**No. EC155-71A015**

# ALERT SERVICE BULLETIN

### POWER PLANT - Firewall

#### Modification of the material of the firewall edging

Figure 1

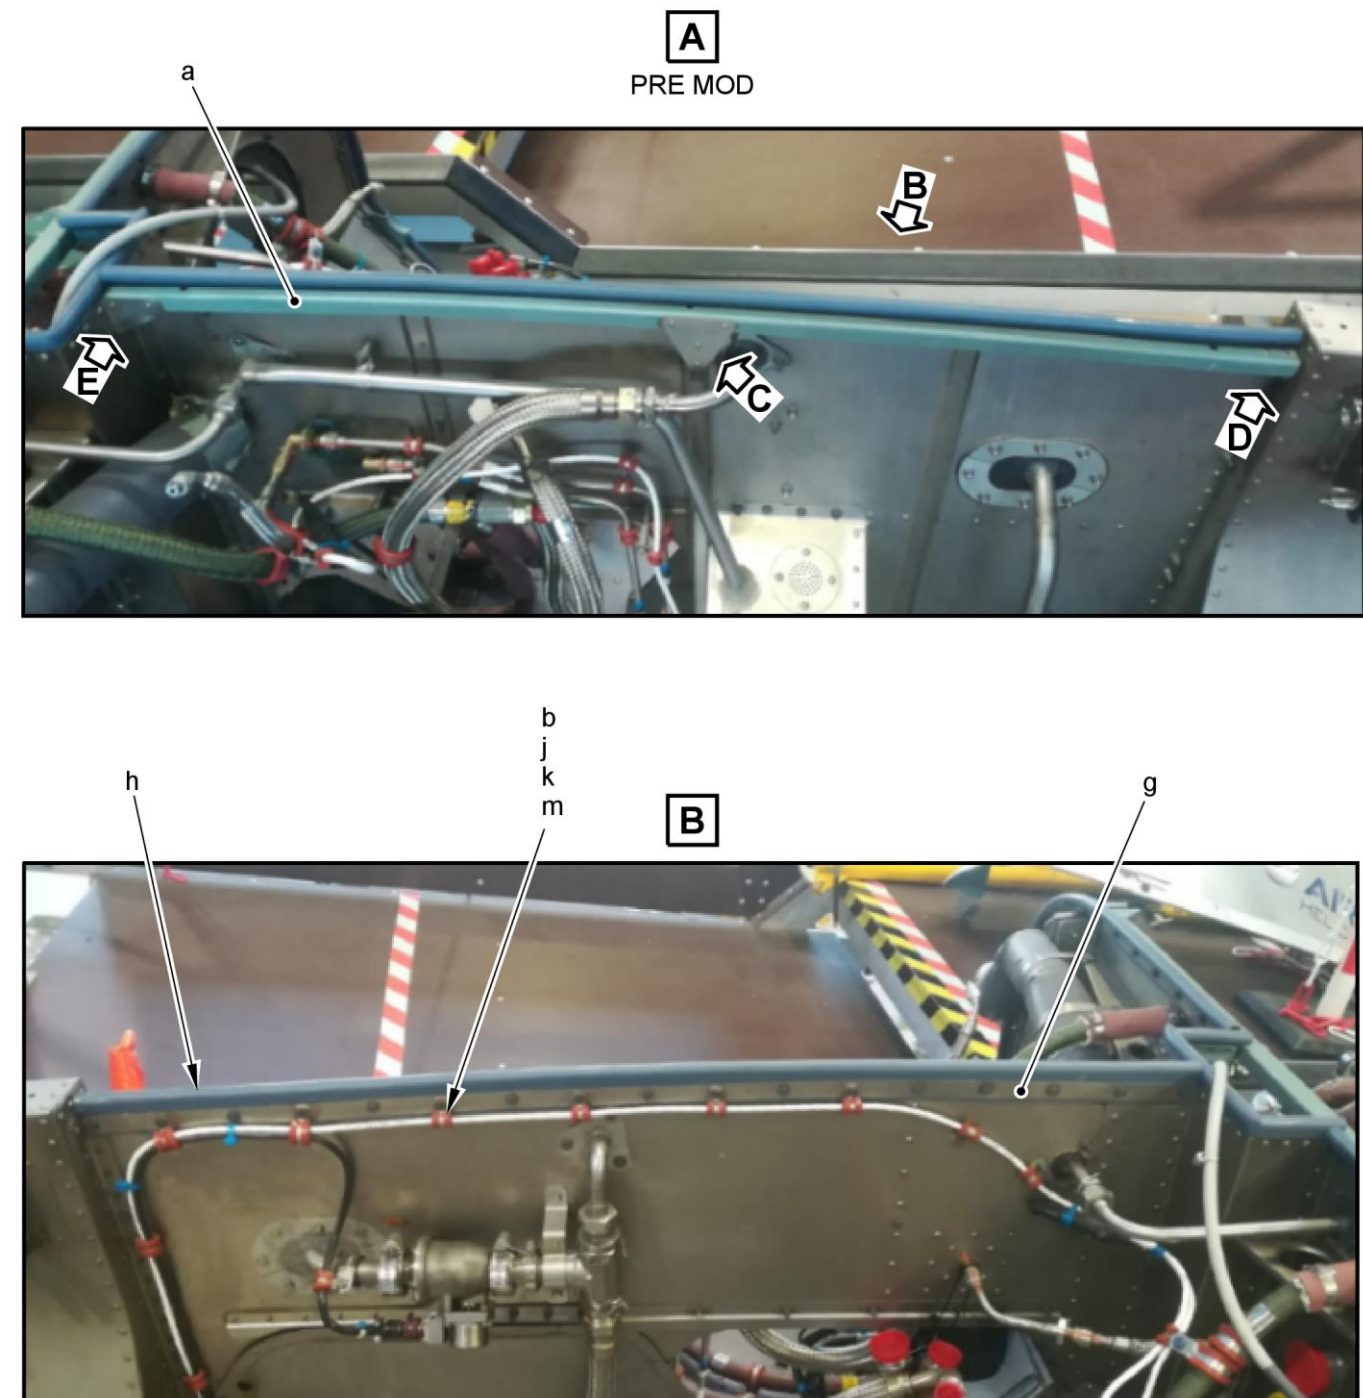
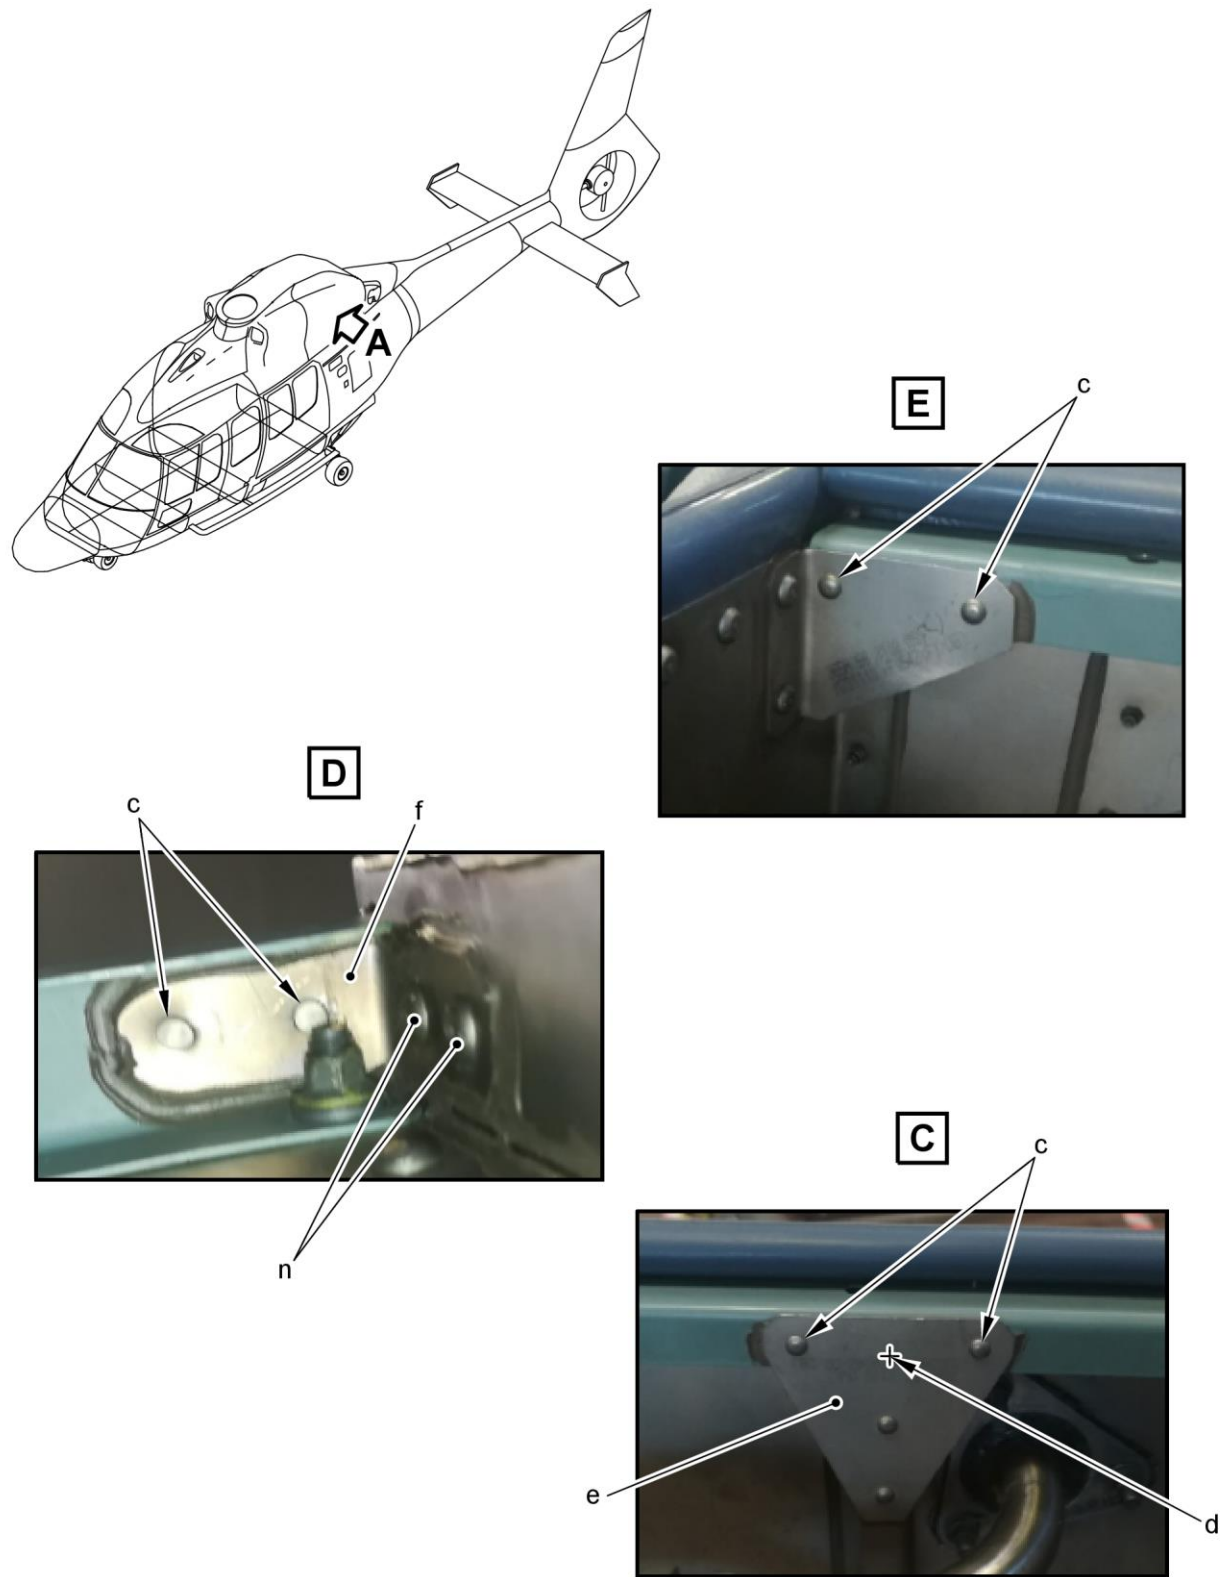
#### 3.B.2.a. Removal of the aluminum stiffener from the firewall ([Figure 1](#))

Refer to DETAIL A, DETAIL C, DETAIL D and DETAIL E:

- Remove the rivets (c) from the stiffener (a). Refer to Work Card 20-03-01-102 (MTC).
- If the center rivet (d) is installed on the gusset (e) (DETAIL C):
  - . Remove the rivet (d). Refer to Work Card 20-03-01-102 (MTC).
- Remove and discard (DETAIL B):
  - . The stiffener (a)
  - . The bolts (b)
  - . The washers (j)
  - . The nuts (k).
- Remove and keep (DETAIL A, DETAIL B):
  - . The cover strip (g)
  - . The fireproof seal (h)
  - . The clamps (m).
- If the bracket (f) is in unsatisfactory condition (DETAIL D):
  - . Remove the rivet (n)
  - . Remove and discard the bracket (f).

Figure 2

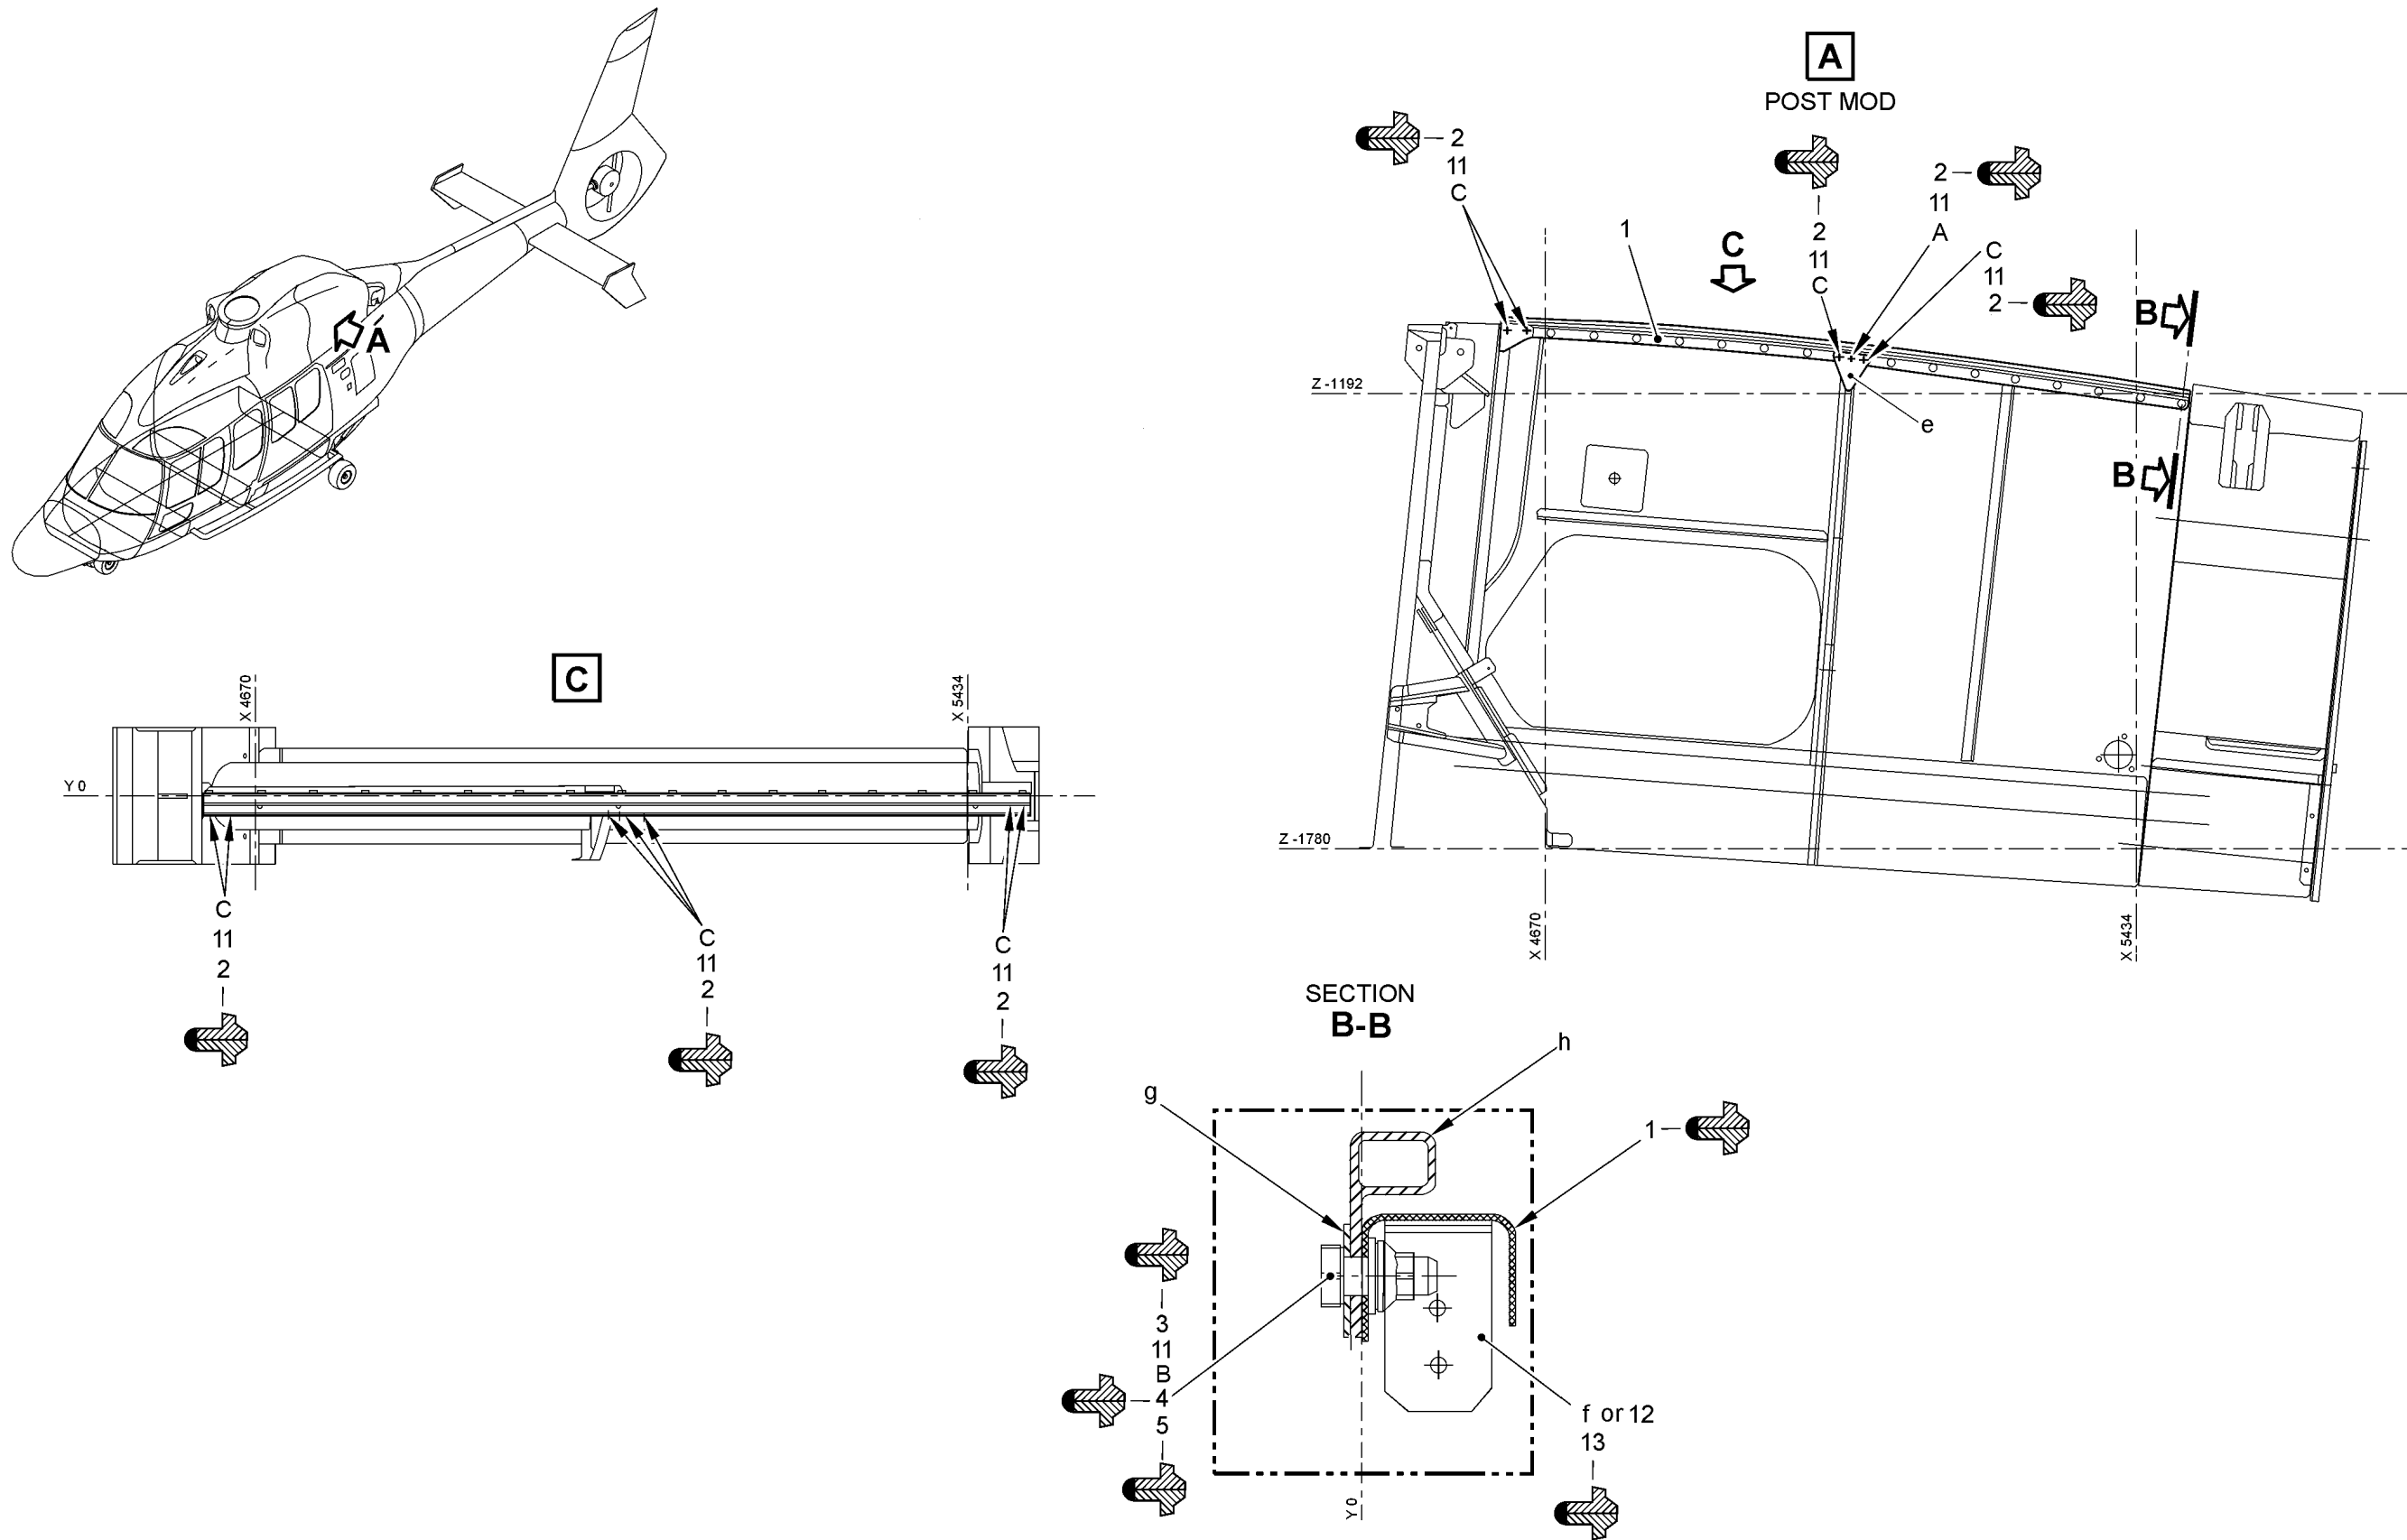
#### 3.B.2.b. Installation of the titanium stiffener on the firewall ([Figure 2](#))

- Put in position the stiffener (1) on the firewall to agree with the existing holes.
- If there is a hole (A) on the gusset (e) (DETAIL A):
  - . Counter-drill the hole (A) to 2.4 mm diameter on the stiffener (1).

- Counterdrill the holes (B) to 5,5 mm diameter to agree with the existing firewall holes.
- Counterdrill the holes (C) to 2,4 mm diameter to agree with the existing firewall holes.

- Deburr and apply protection with interposition sealant (11) to the holes (A), (B) and (C). Refer to Work Card 20-05-01-227 (MTC).
- If the bracket (f) is removed:

- . Replace it with a new bracket (12) (SECTION B-B). Refer to paragraph [2.C.](#)
  - . Install the new bracket (12) on the firewall with rivets (13).

- Install all the rivets (2) on the stiffener (1), the gusset (e) and the bracket (12) or (f) with the sealing compound (14) (DETAIL A and DETAIL C). Refer to Work Card 20-03-02-406 (MTC) and Work Card 20-05-01-222 (MTC).

- Do a check of the cover strip (g) and the fireproof seal (h) to replace if necessary (SECTION B-B). Refer to Work Card 71-30-10-702 (AMM).
- Install the stiffener (1), the cover strip (g) and the seal (h) (DETAIL A, DETAIL C and SECTION B-B) with:

- . The bolts (3)
  - . The washers (4)
  - . The nuts (5)
  - . The clamps (m) (not shown)
  - . The sealing compound (14). Refer to Work Card 20-05-01-222 (MTC).
